Submissions Report

EnergyConnect (NSW – Eastern Section)

May 2022

Figure D-1

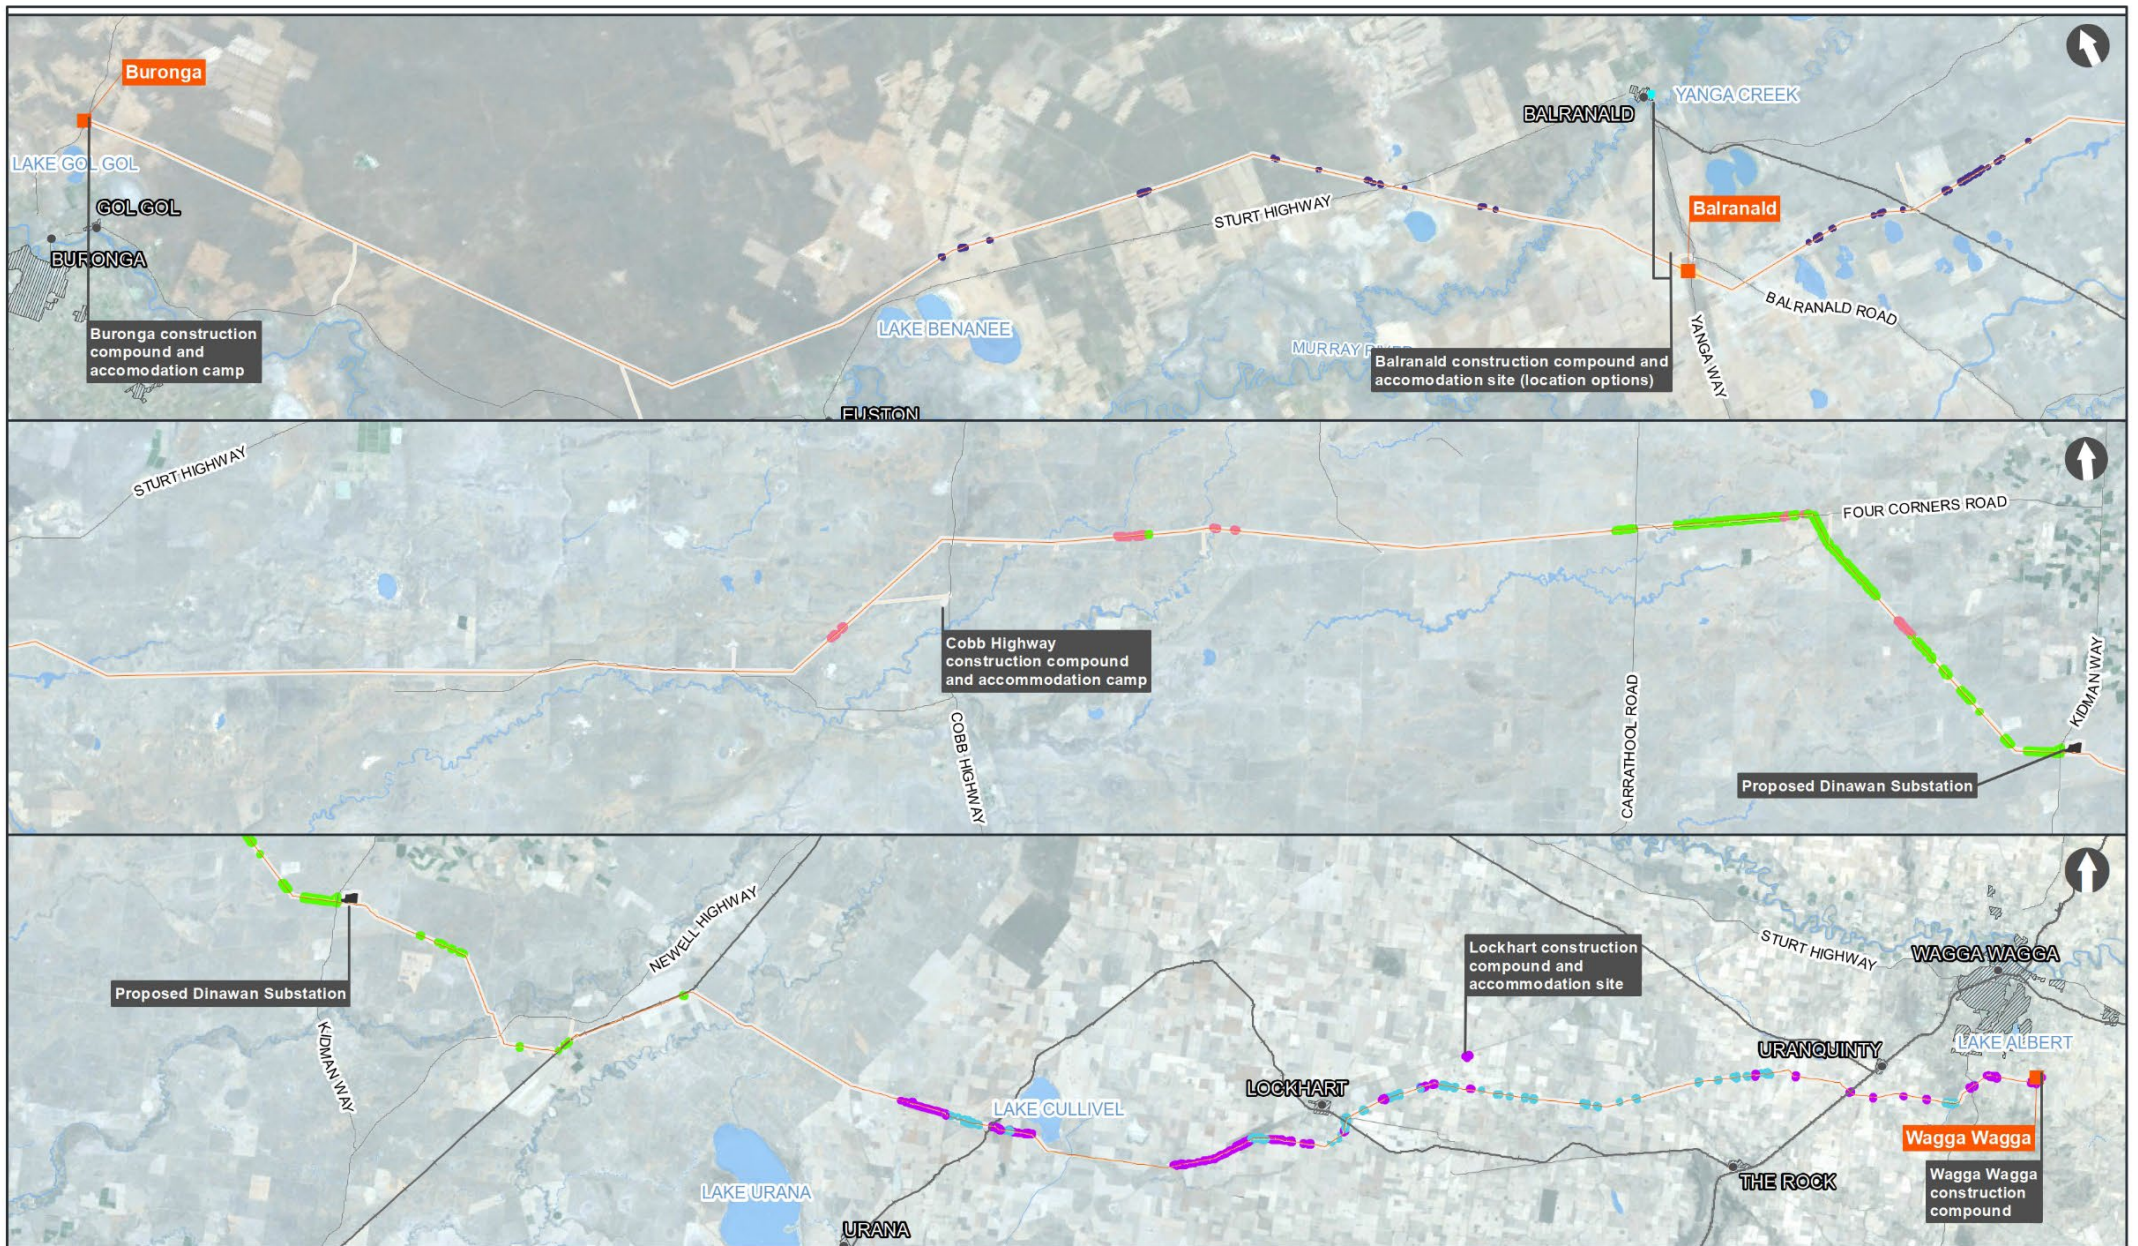
Provide two summary figures (one for BC Act and the other for EPBC Act listed TECs) showing the approximate location of the TECs along the alignment – preference for each figure to be one page – similar per BDAR Figure 3–3 if scale allows.

Summary figures showing the approximate location of the identified TECs along the length of the refined alignment have been included as Figure D-1 and Figure D-2 below. These figures show the listed TECs under both the BC Act and EPBC Act respectively. These figures represent a summary of the more detailed figures from Appendix B–6 and Appendix D–2 of the Revised BDAR respectively.

Figure D-5 (EIS Figure 6-5)

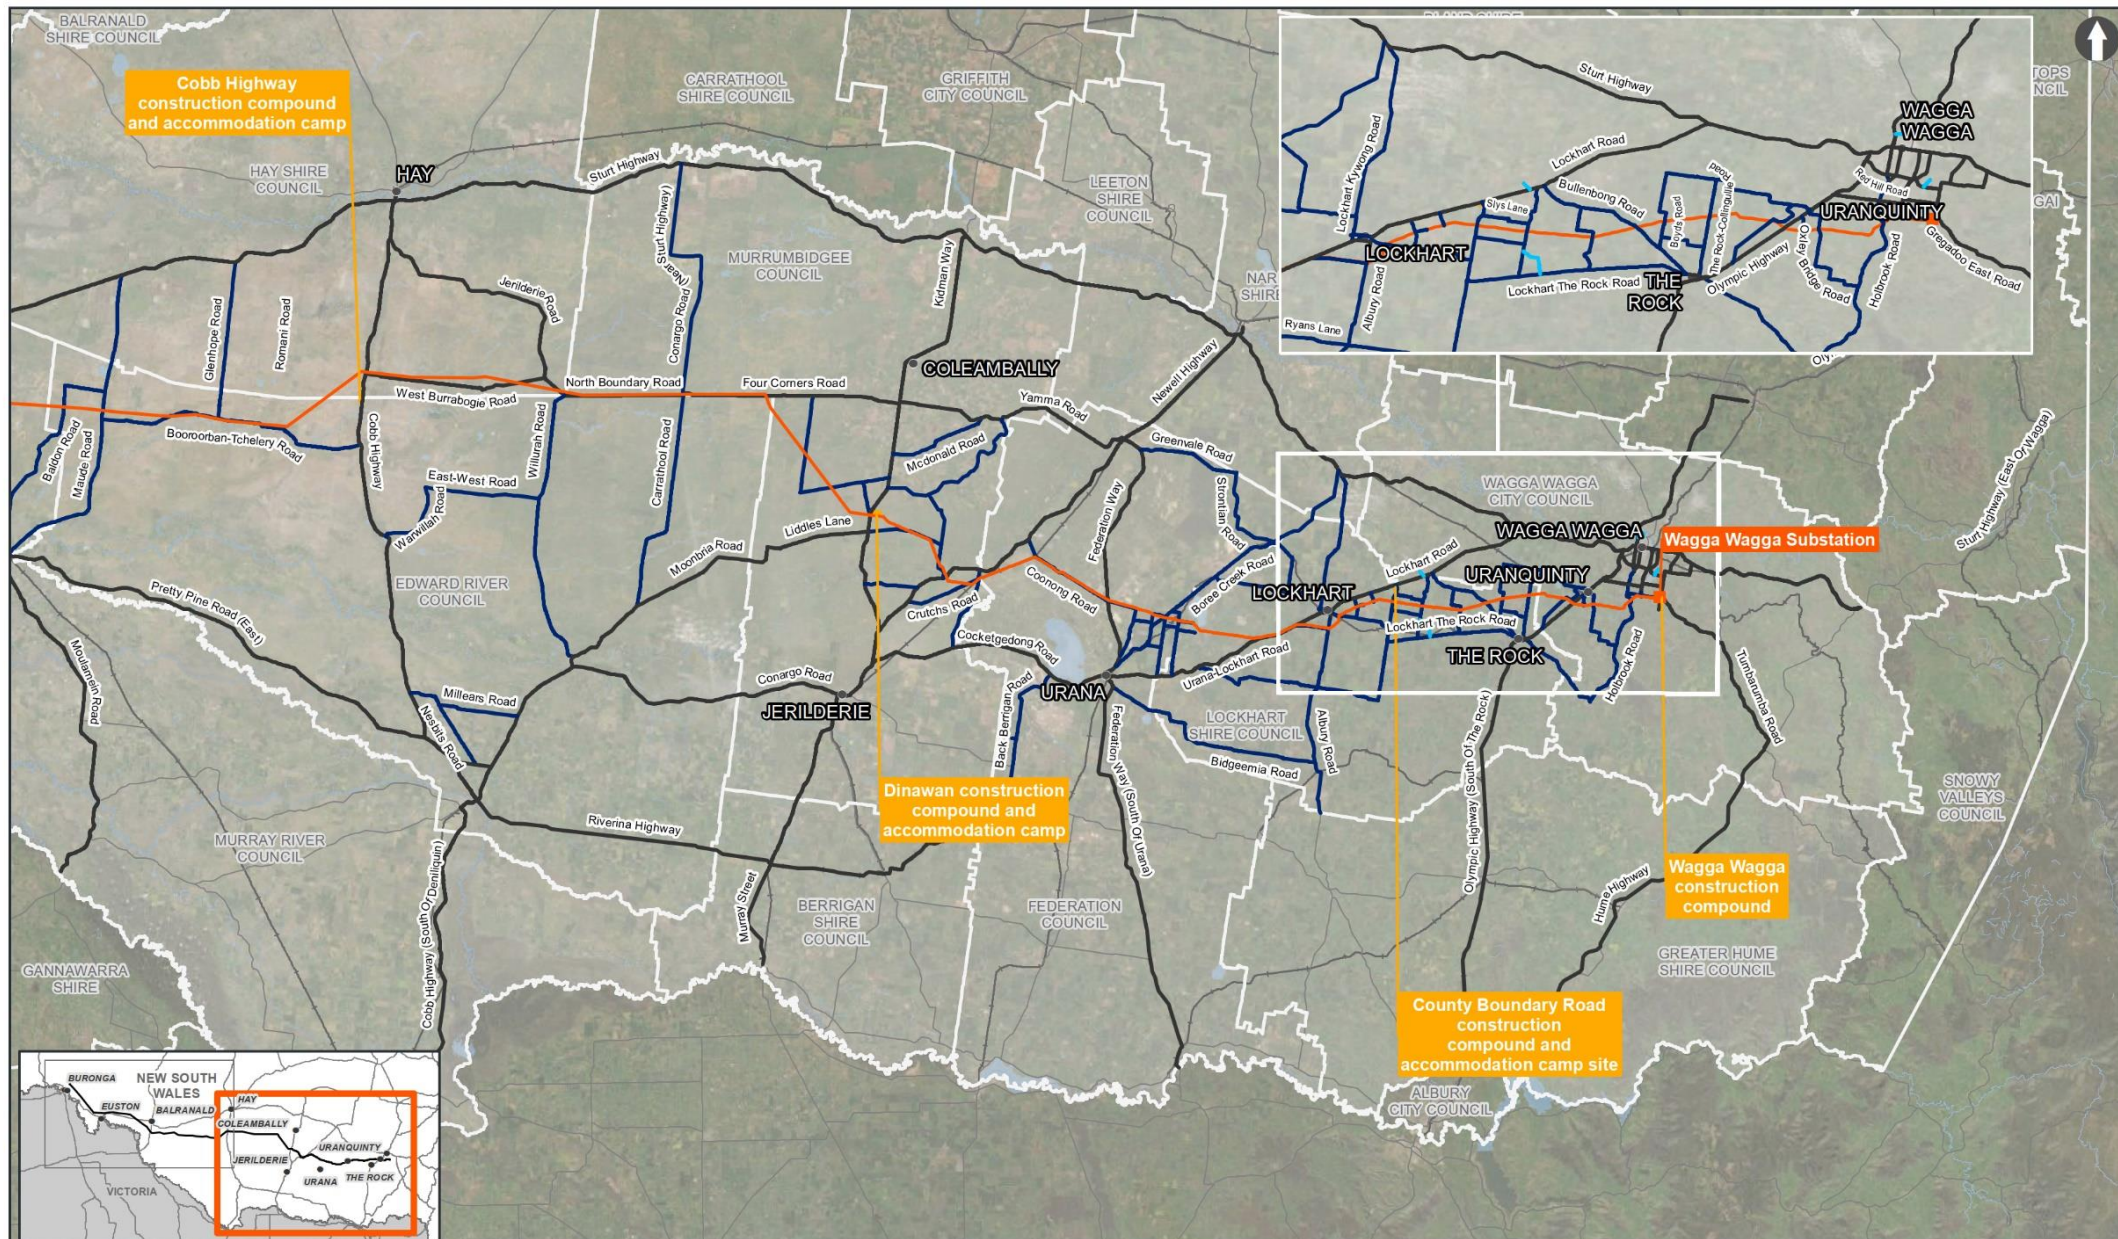
EIS Figure 6–12 – add road names to inset

Figure 6–12 has been updated to include road names (where possible) to the insert of the Wagga Wagga section of the alignment. This map has been included below as Figure D-5.

Figure D-6

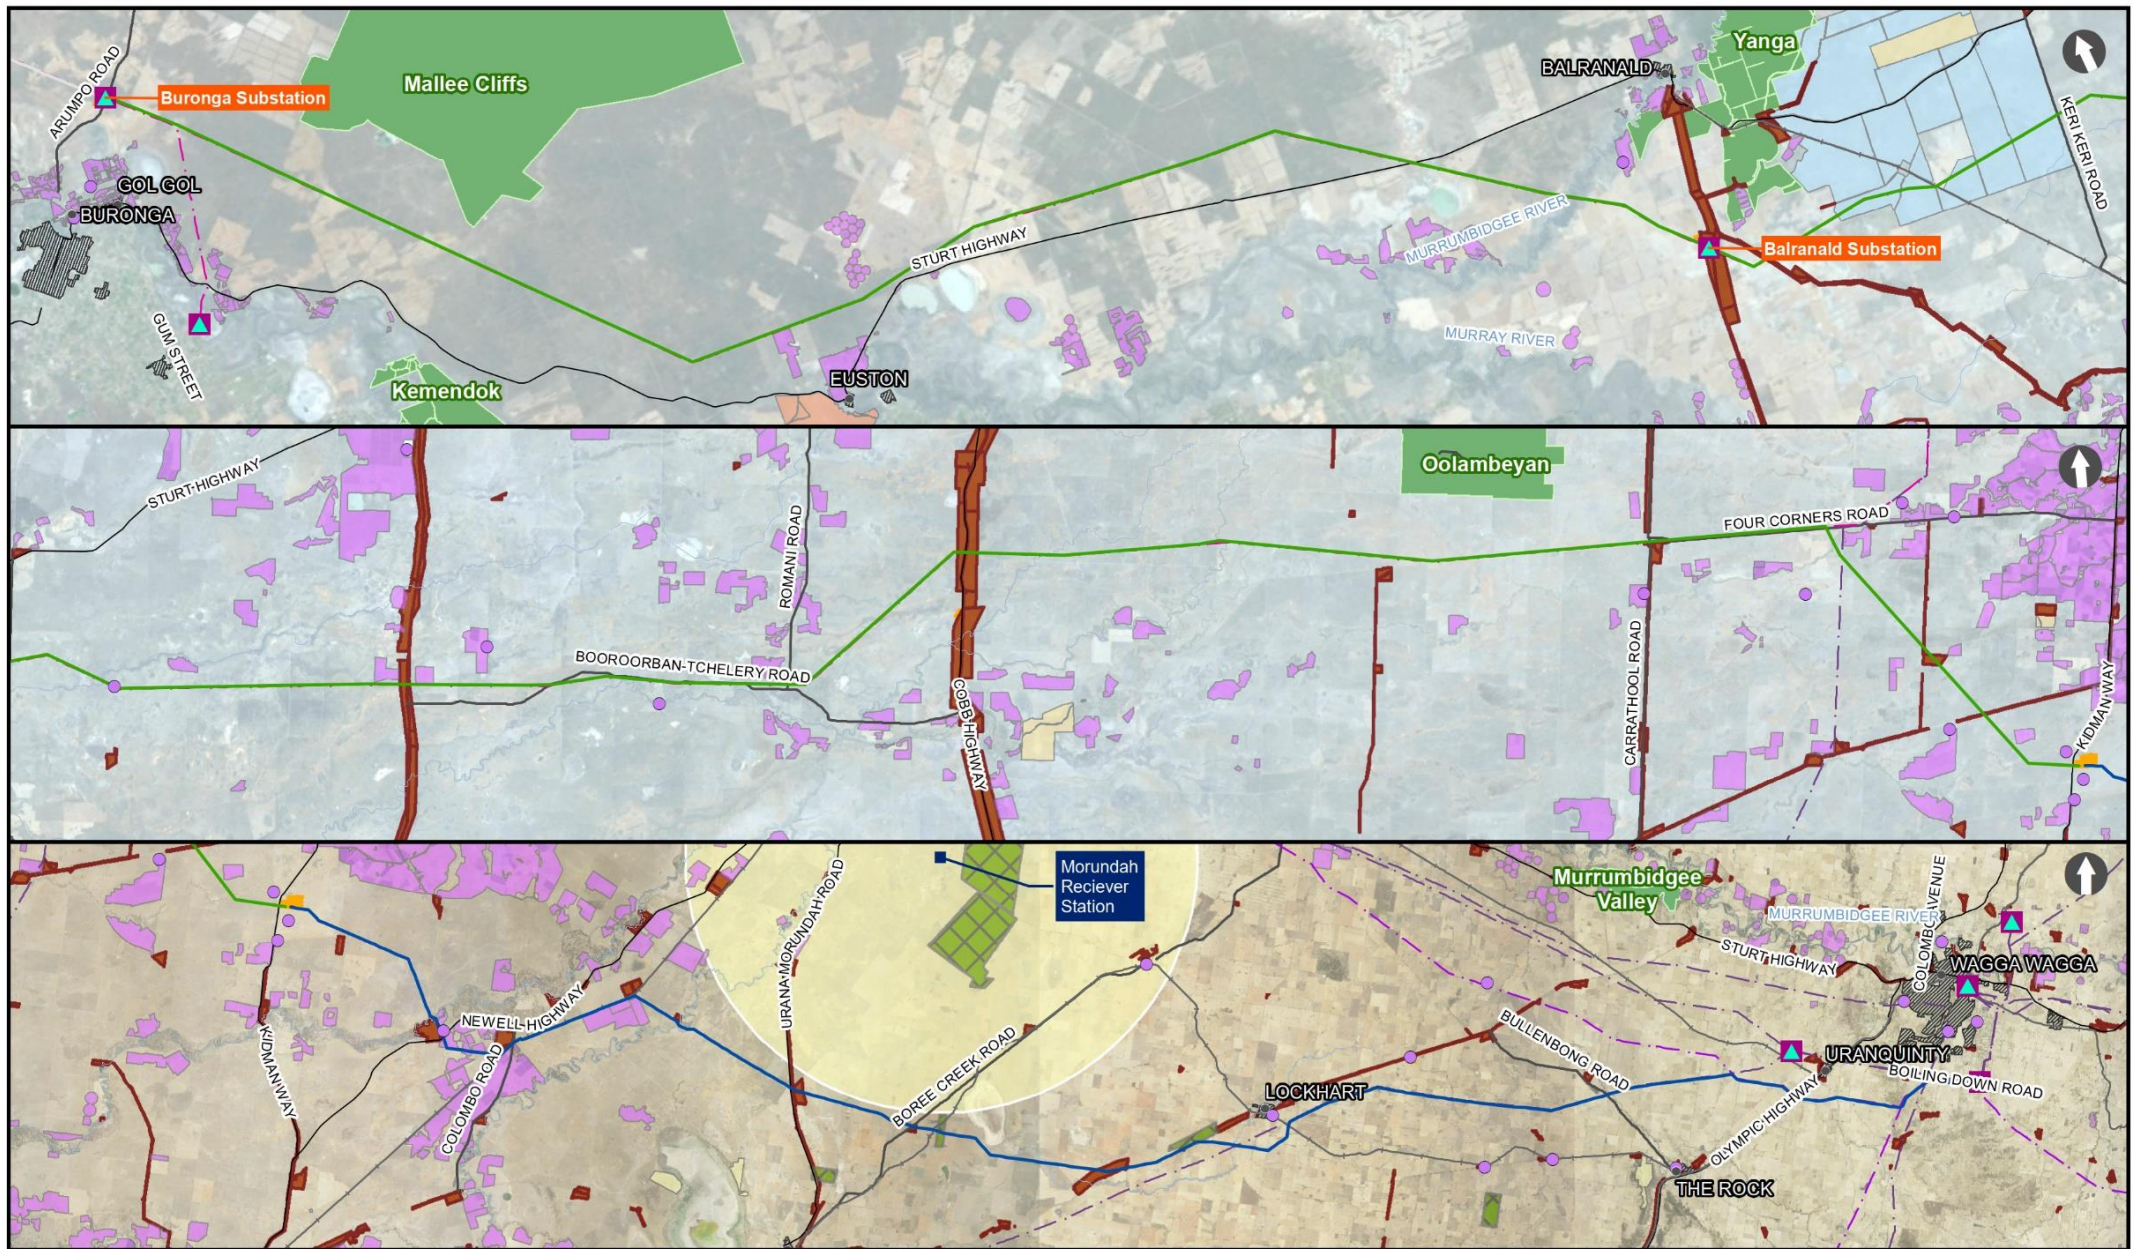
- preference is for one figure with three sections (as per EIS Figure 9–3)
- include project infrastructure
- clearly show and label major watercourses and lakes
- identify major roads and towns, national parks and conservation areas and key irrigation areas
- plus anything else of importance to landscape context as needed (i.e. features that may have been avoided by the project)

A new figure identifying the key landscape features in proximity to the transmission line corridor which incorporate the key features identified above has been prepared. This map has been included below as Figure D-6.
